# PICCADILLY WAREHOUSE

Mindel House & Bloom Street

Design and Access Statement Addendum

Section 73/19

Mindel House. Upper Ground Floor

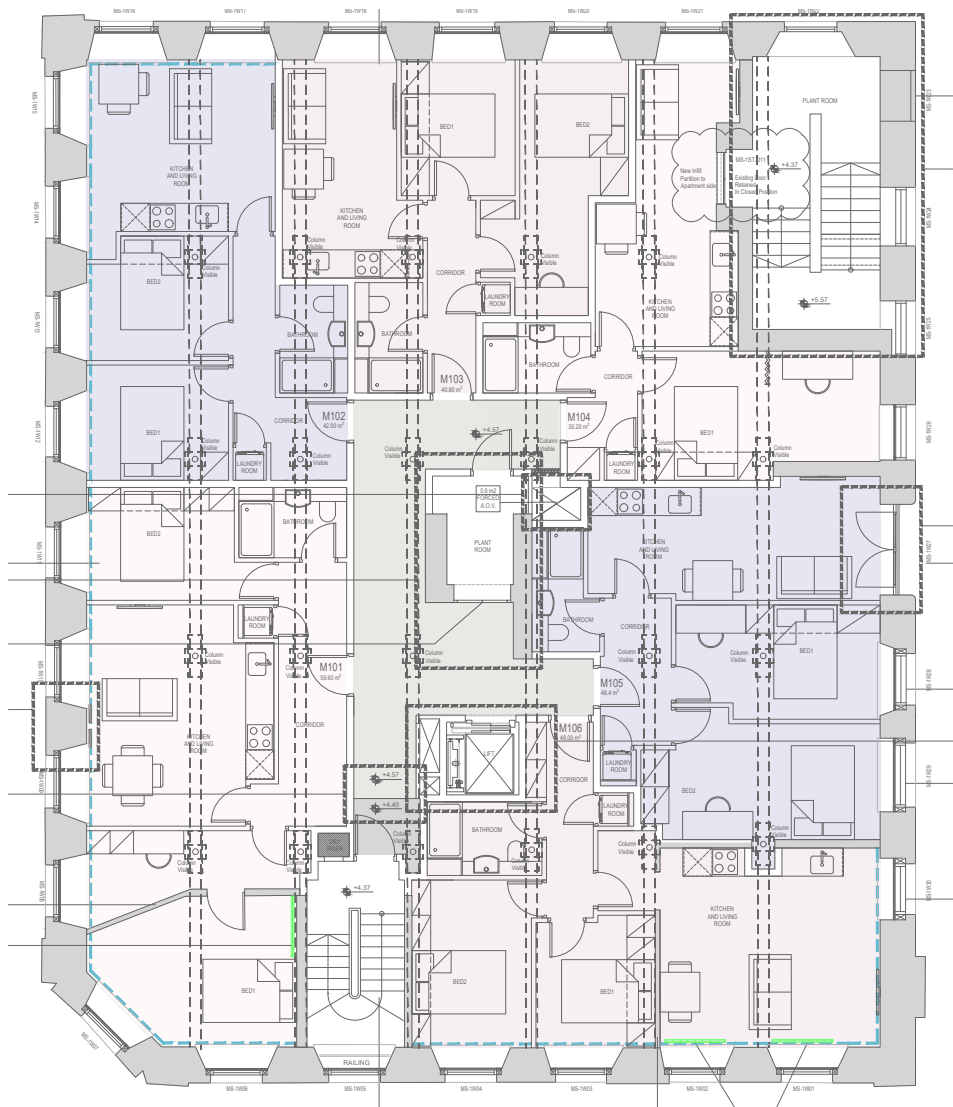
- Apartment layout: Improved efficiency and open plan arrangement where possible.
- Main stair handrail: to be upgraded to comply with minimum height requirement. Additional top rail required possibly without interfering with original balustrade.

**A** Alleyway entrance: Design revised to fit area (now surveyed) with finishes for new elements now coordinated with Bloom Street Alleyway entrance.

**B** Historic sprinkler valves+pipes: Now proposed to be refurbished and relocated within stair lobby

**C** Plantroom: Mechanical plant added for functional reasons.

**D** Apartment reconfiguration: Approved 2 Bedroom apartment redesigned to 1 Bedroom to provide a suitable kitchen/living space.

Mindel House. First Floor

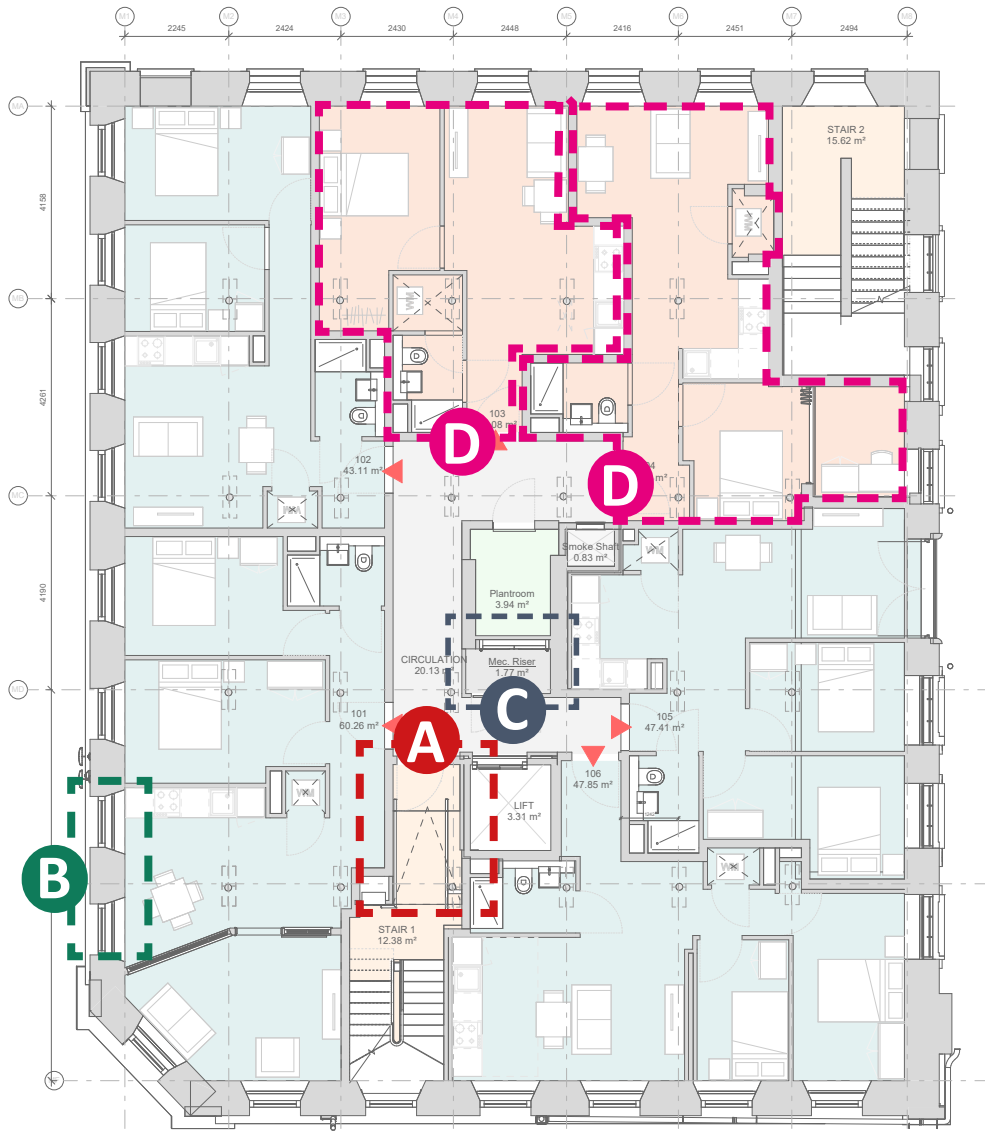
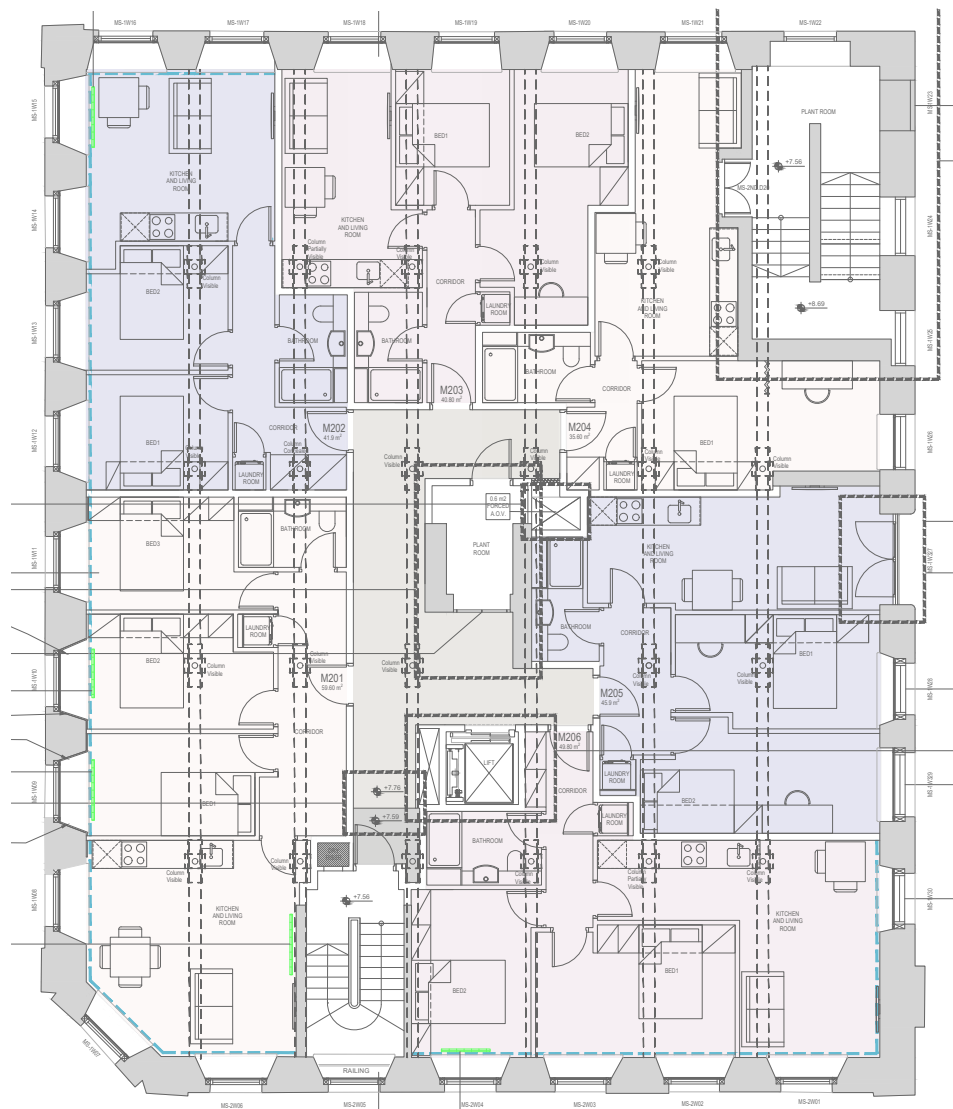
- Apartment layout: Improved efficiency and open plan arrangement where possible.
- Main stair handrail: to be upgraded to comply with minimum height requirement. Additional top rail required possibly without interfering with original balustrade.

- A** Stair lobby: Extended to incorporate ramp needed to address the change of level
- B** Historic sprinkler valves+pipes: Now proposed to be refurbished and relocated within stair lobby
- C** Plantroom: Mechanical plant added for functional reasons.

- D** Apartment reconfiguration: The two apartments are redesigned together to provide better accommodation. As a result, one of the apartment has been reduced from 2 Bedrooms to 1.

Mindel House. Second/Third Floor

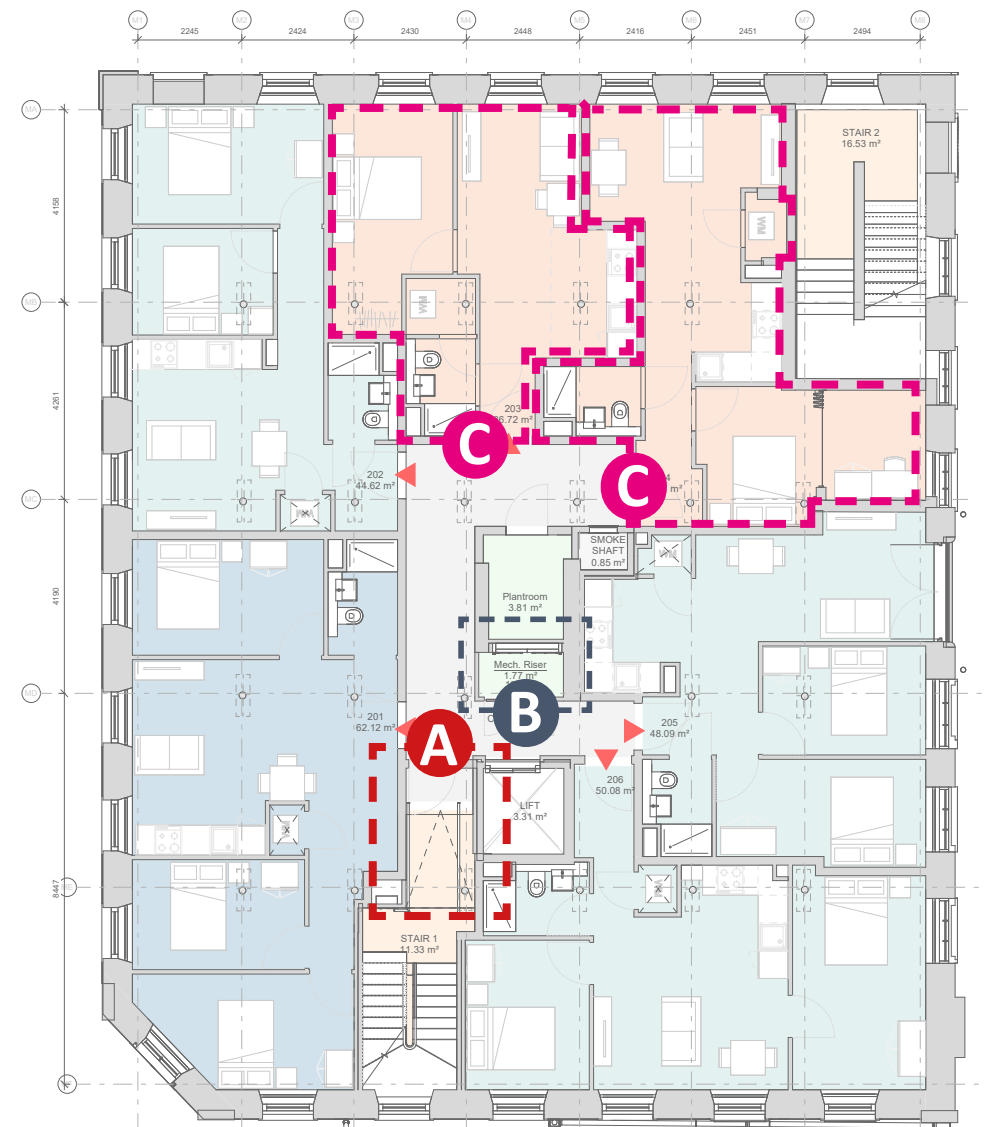
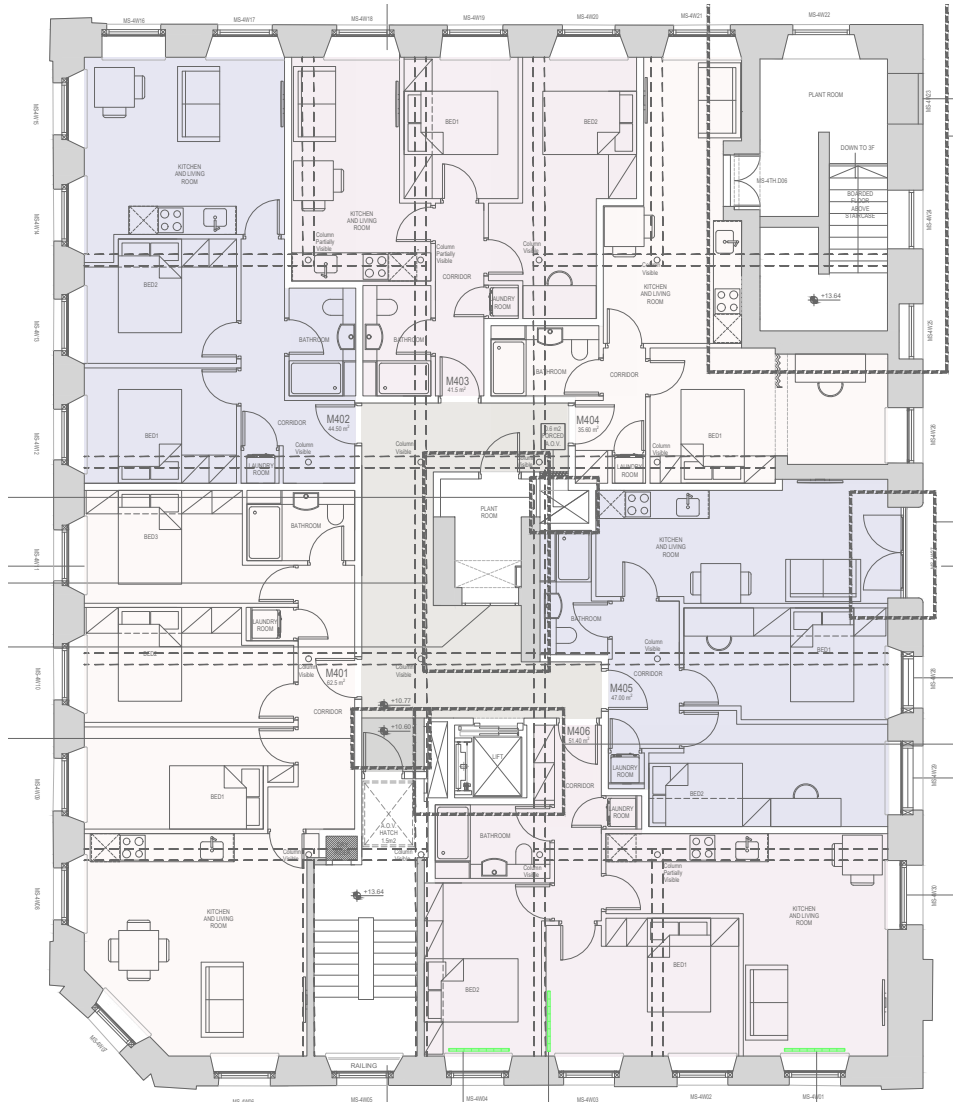
- Apartment layout: Improved efficiency and open plan arrangement where possible.
- Main stair handrail: to be upgraded to comply with minimum height requirement. Additional top rail required possibly without interfering with original balustrade.

Stair lobby: Extended to incorporate ramp needed to address the change of level

Plantroom: Mechanical plant added for functional reasons.

Apartment reconfiguration: The two apartments are redesigned together to provide better accommodation. As a result, one of the apartment has been reduced from 2 Bedrooms to 1.

Mindel House. Fourth Floor

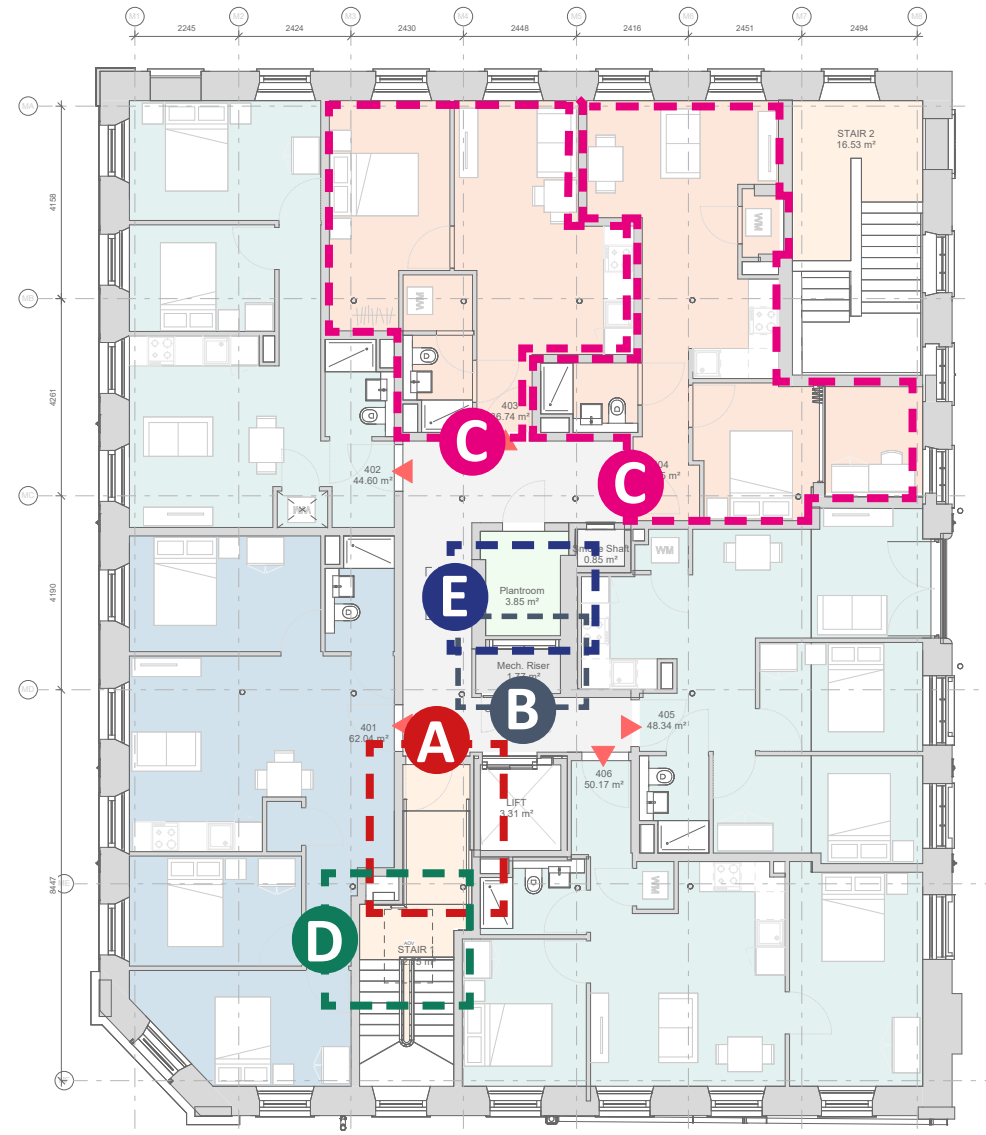
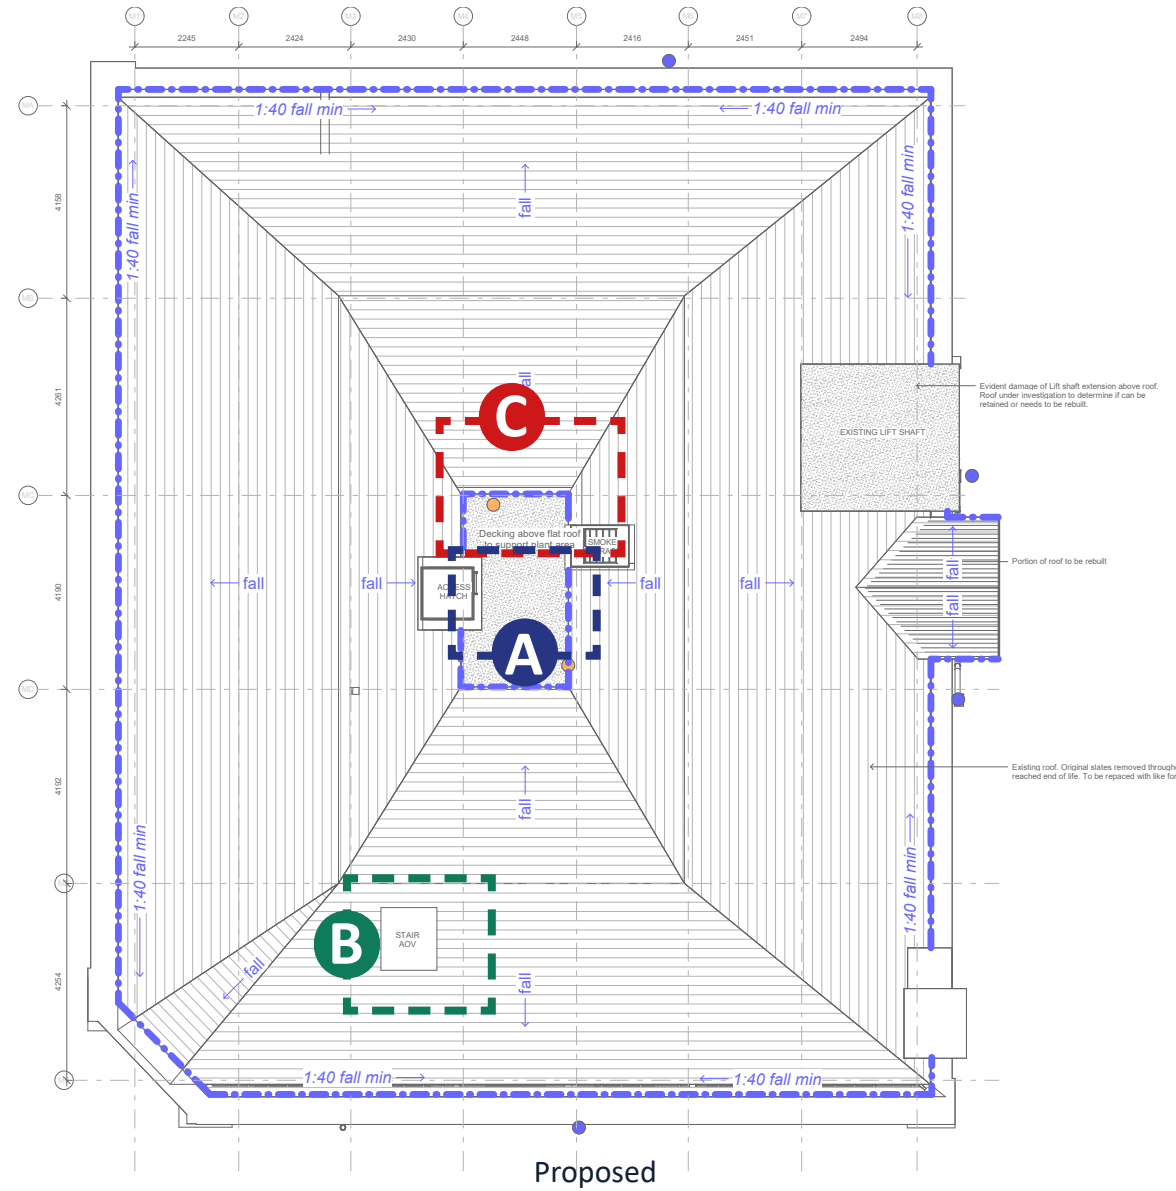
A.O.V Hatch: Approved location above lobby not functional. Proposed to be relocated above stairs.

Masonry Hoist: Proposed to be cut below central flat roof level to make space for required plants.

Mindel House. Roof plan

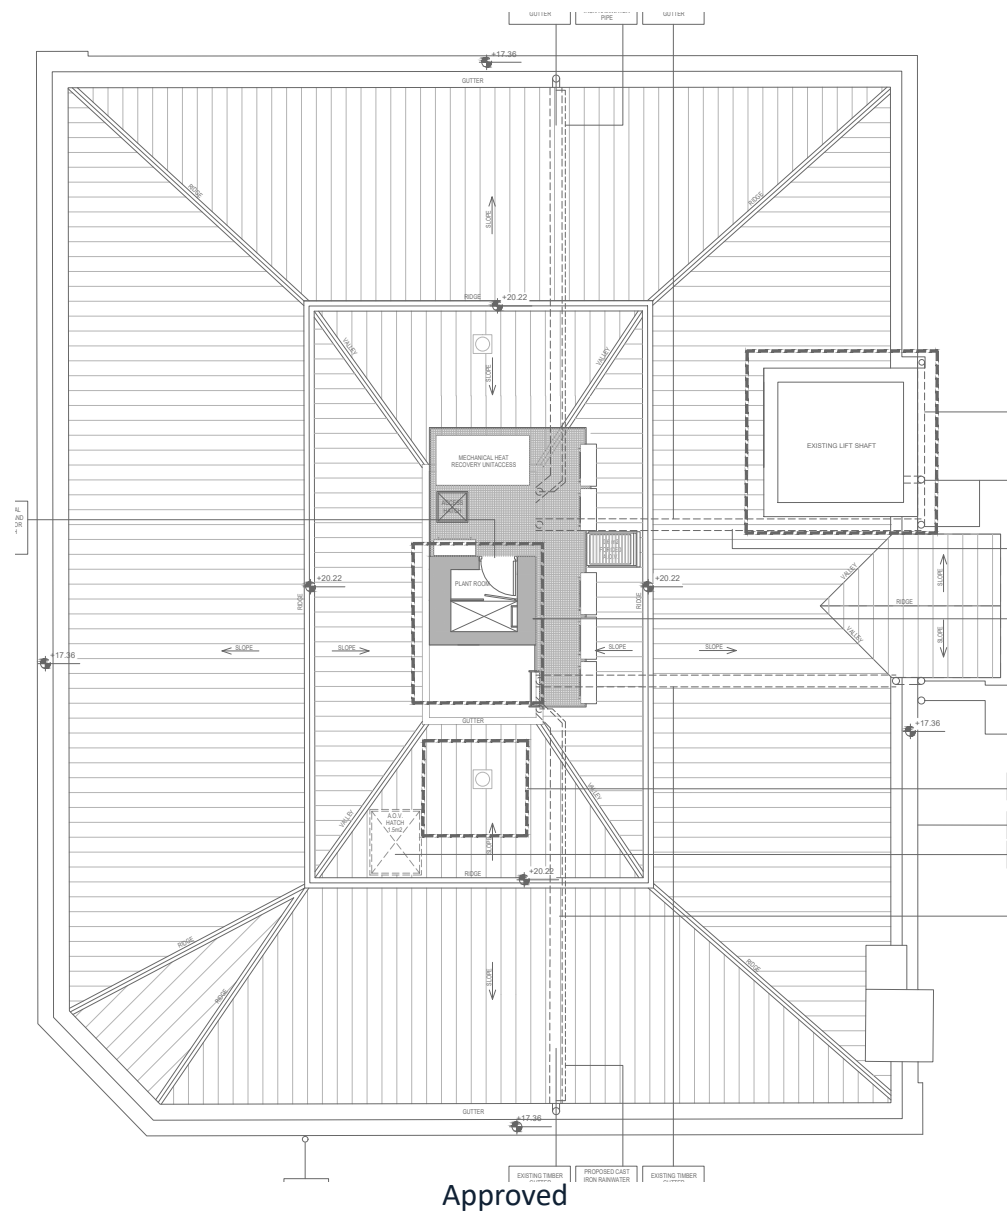
- A** Masonry Hoist: Proposed to be cut below central flat roof level to make space for required plants.
- B** A.O.V Hatch: Approved location above lobby not functional. Proposed to be relocated above stairs.
- C** Roof plant meta deck: Reduced in size. Now matching extent of central flat roof.
